MURPHY - KELLER
EDUCATIONAL CENTER

HEIFER
INTERNATIONAL
CENTER

CONTENTS:
PLUMBING PLAN

Δ 02/27/09 ASI #37

ENLARGED KITCHEN EQUIPMENT PLUMBING FIRST FLOOR PLAN
SCALE: 1/4"=1'-0"

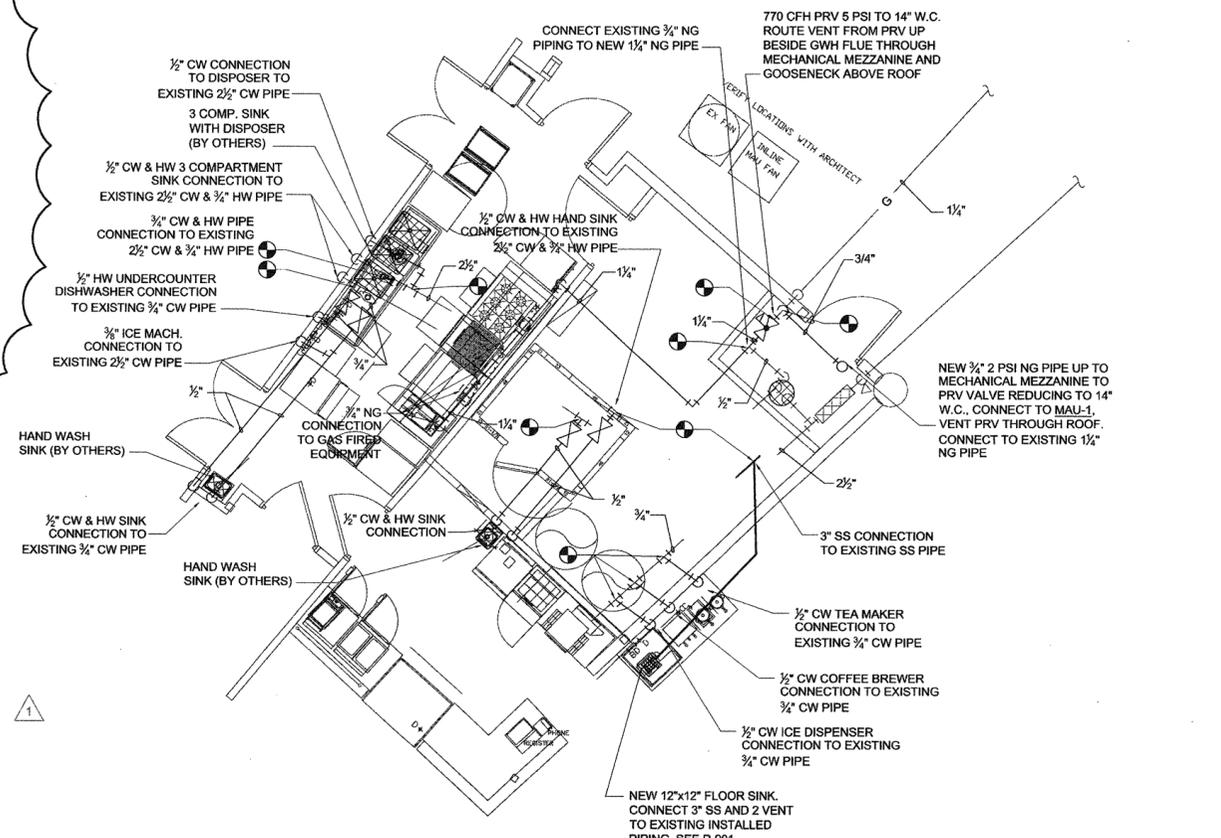
GENERAL NOTE:
1. REMOVE EXISTING SITE REGULATOR TO INCHES W.C. AND
INSTALL NEW REGULATOR TO 5 PSI. INSTALL NEW
REGULATOR AT ENTRY TO EXISTING BUILDING FROM 5 PSI TO
INCHES W.C. AT SAME CAPACITY OF EXISTING REGULATOR.
2. HAND SINK AND THREE COMPARTMENT SINK PIPING FROM
MAIN TO FIXTURE MAY ALREADY BE INSTALLED.
CONTRACTOR TO VERIFY PRIOR TO BID.
